Subject: LaSalle County Nuclear Power Station Units 1 and 2

Commonwealth Edison Company Response to NRC's questions
regarding company's Thermo-Lag Test Program

NRC Dockets 50-373 and 50-374

Test Configuration Drawings

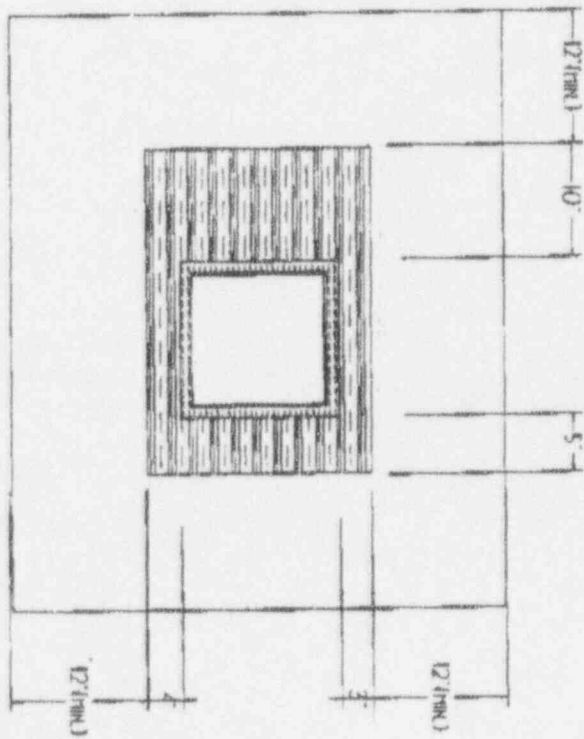
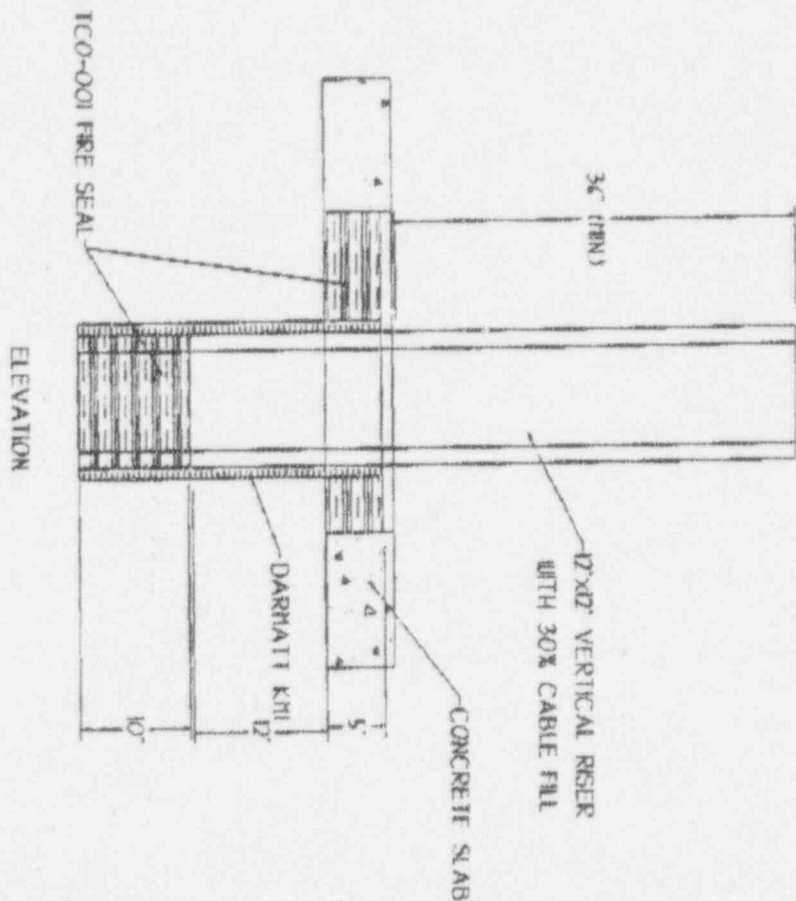
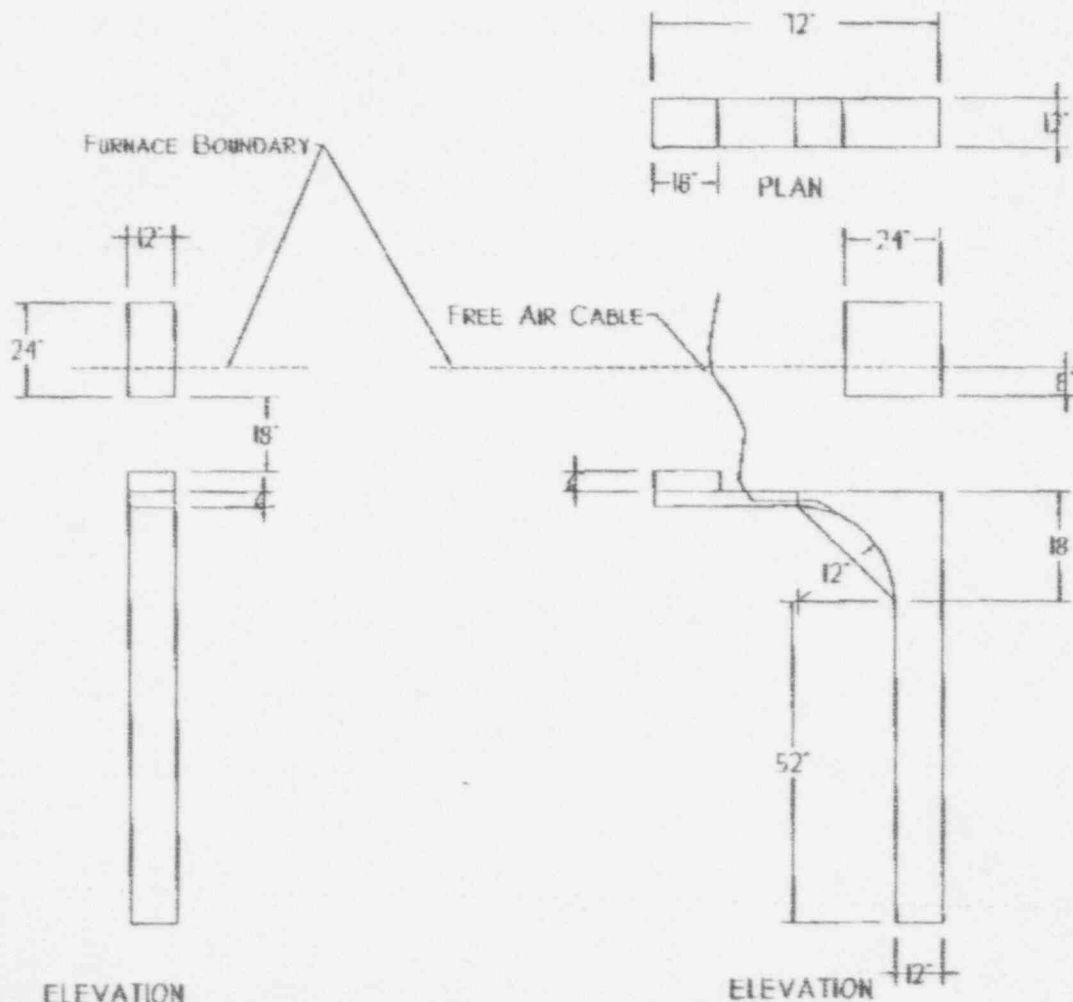
- II Based on its review of your program, the staff does not consider the proposed cable tray fire barrier test configuration to be representative of the proposed field condition.

The test assembly was constructed to be representative of the worst case conditions for the proposed field application. The worse case was identified as a large "L" shaped structure with minimal thermal adsorption. To minimize the material available to act as a heat sink, only one cable tray was included and it did not contain cabling or Thermo-Lag material which would provide additional thermal adsorption. The fire test assembly consisted of a single horizontal run of 4"x30" wide solid back steel cable tray. The long leg of the "L" leg is enclosed in a structural steel frame. The wall and ceiling of the two sides are concrete with the other two surfaces (away from the wall) protected with DARMATT KM1 material. The other leg of the "L" shape will come out of the enclosure and will be protected on all four sides with DARMATT material. Included with the tray specimen are various hangers, penetrating conduit (both protected and unprotected), and a junction box. When actually installed at LaSalle, two trays will actually be enclosed within the DARMATT material in a configuration that is consistant with the configuration tested.

Generic Letter 86-10 Supplement 1 was used for acceptance criteria for this test. ASTM E-119 was used to determine the exposure fire.

Test Configuration Drawings are provided as Attachment 6.
